RE: **Volcano Cliffs Subdivision Lot 5 Block 6 Unit 19**
7816 Urraca St NW
Grading and Drainage Plan
Engineers Stamp Date 11/23/16 (D10D003F25)

Based upon the information provided in your submittal received 12/1/16, this plan is approved for Grading Permit and Building Permit.

DRAINAGE AND TRANSPORTATION INFORMATION SHEET (REV 09 2015)

GRADING AND DRAINAGE PLAN
LOT 5, BLOCK 6, UNIT 19, VCS
ADDRESS: 7816 Urraca Street, NW

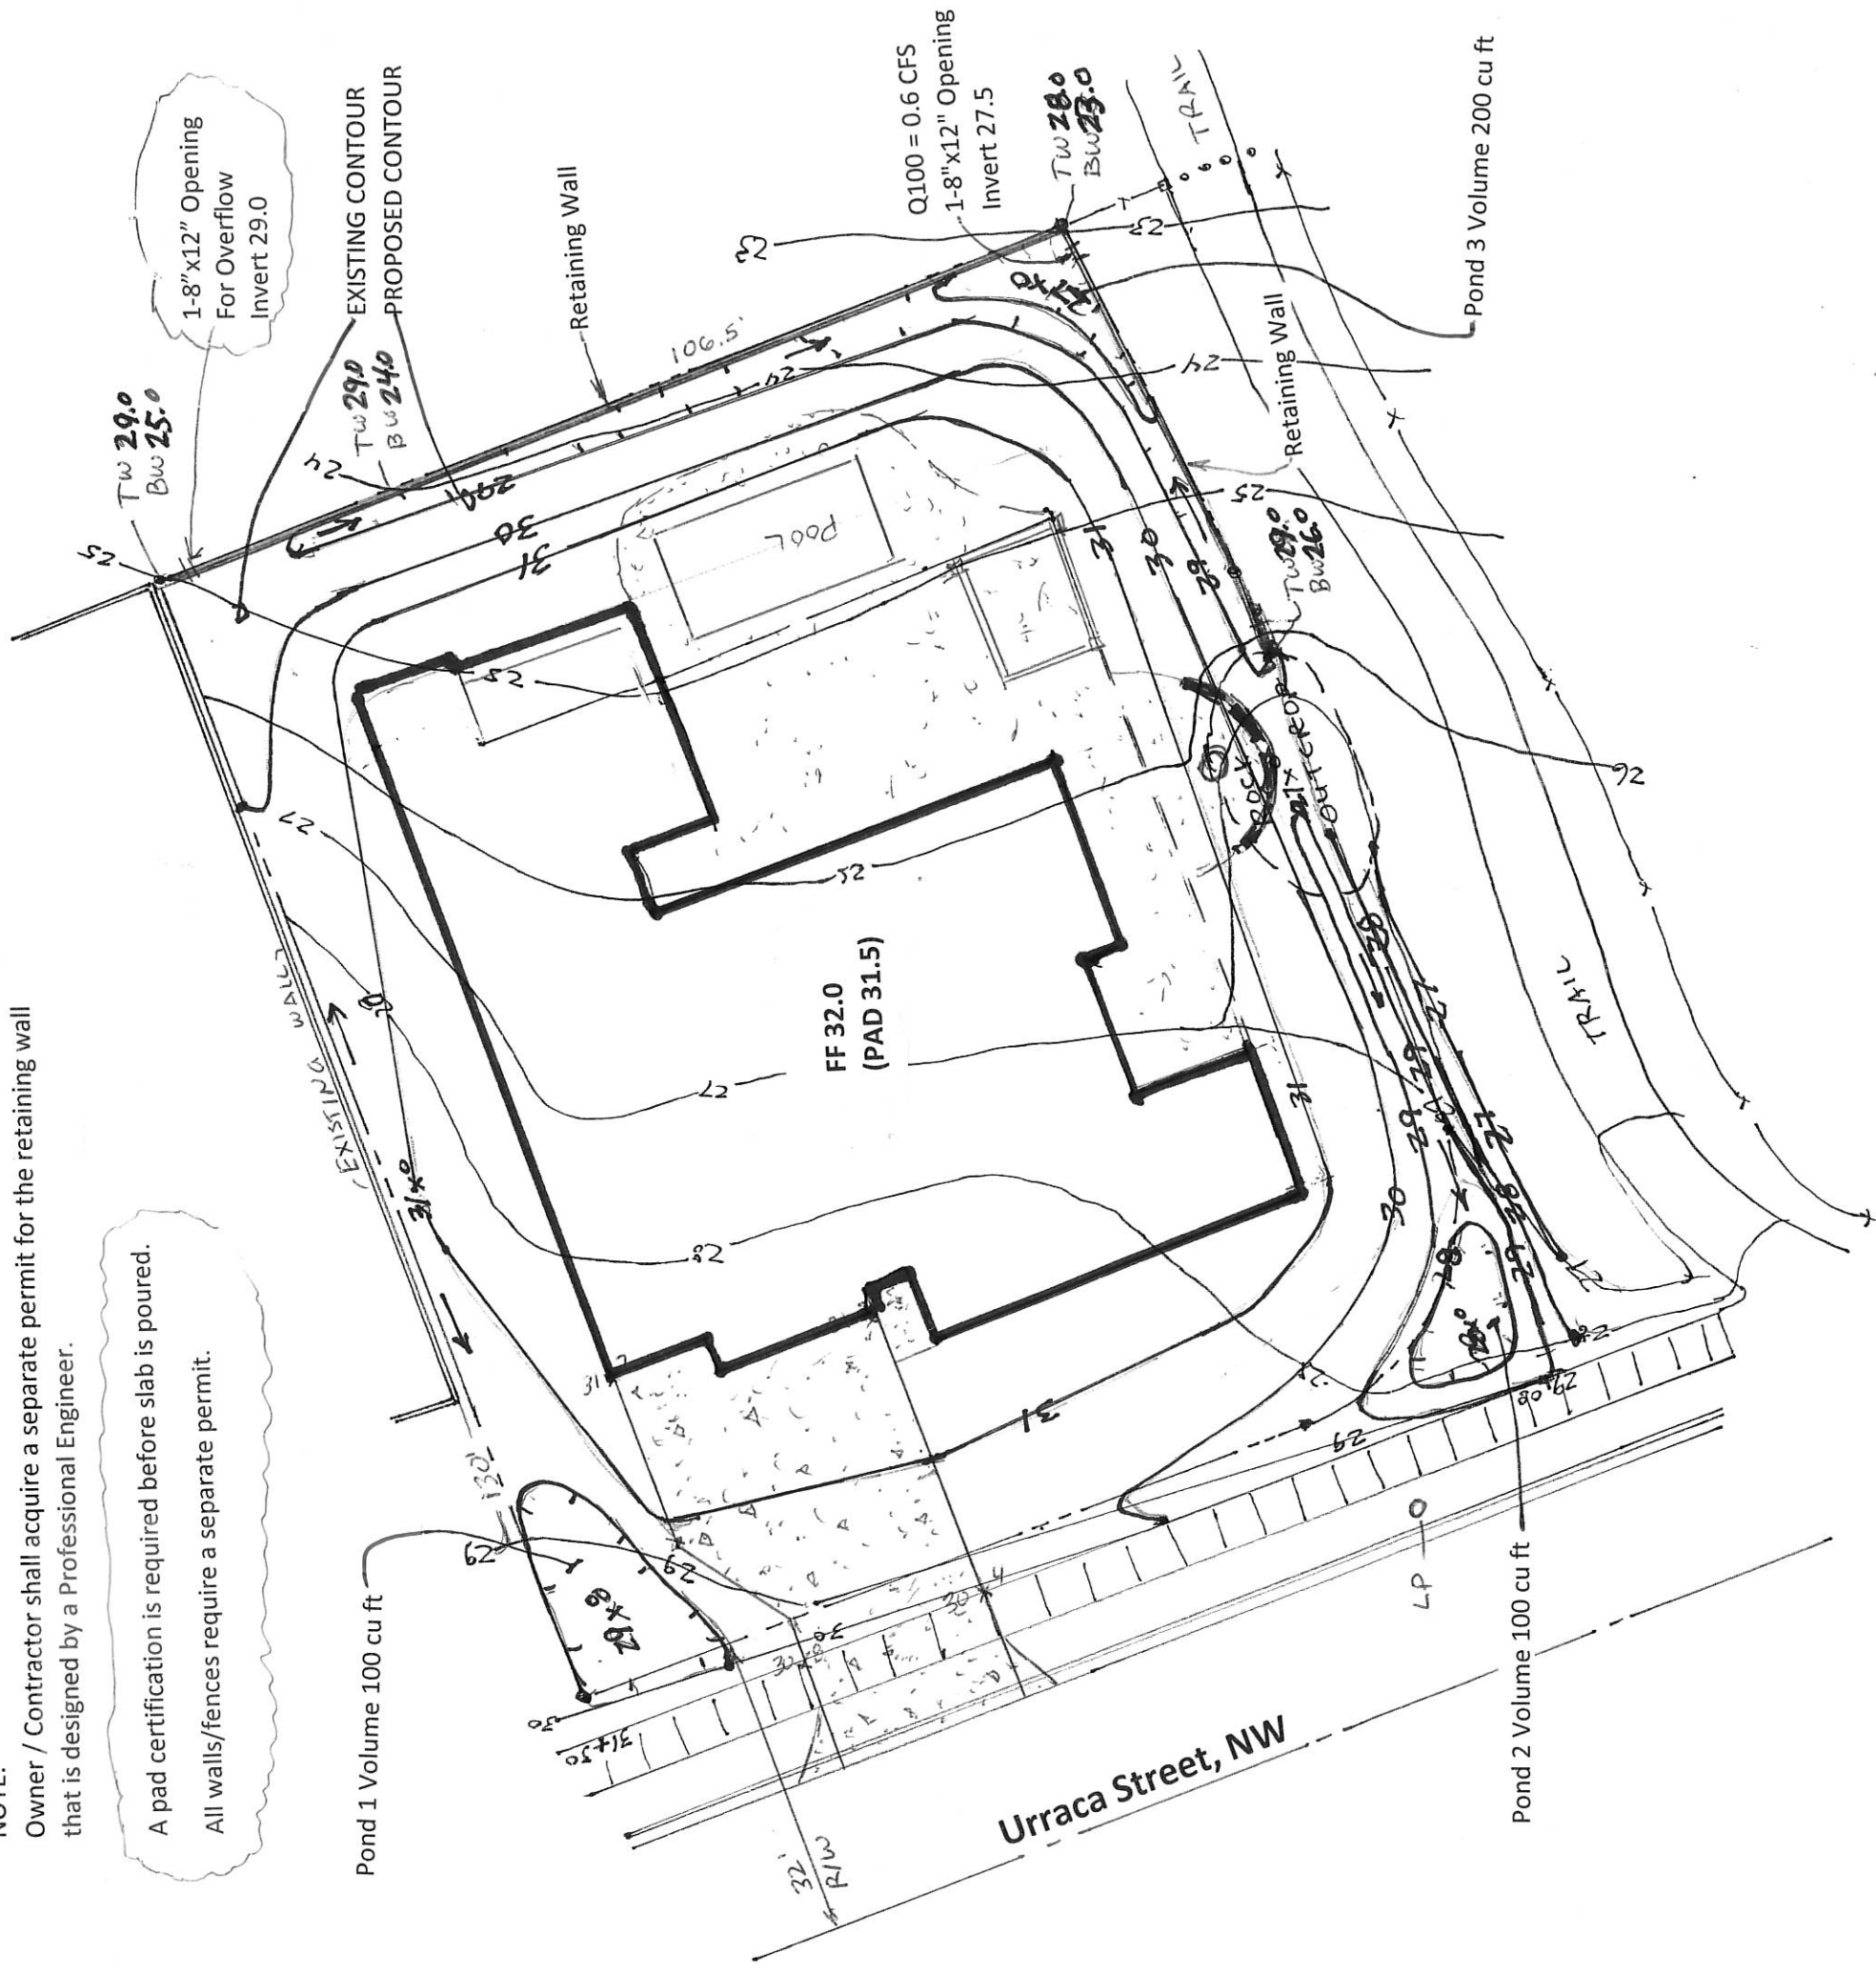
Please attach a copy of this approved plan to the construction sets in the permitting process prior to sign-off by Hydrology. Also, please advise the owner/contractor that a separate wall permit must be obtained and this approved grading plan dated 11/23/16 must be provided with the wall permit application. Also, please advise the contractor/owner that the ponds must stay in place or CO will not be granted.

A pad certification is required before concrete is poured, either by a letter from you stating that the pad is built according to the plan submitted or by an as-built with elevations plotted.

Prior to Certificate of Occupancy release, Engineer Certification per the DPM checklist will be required.
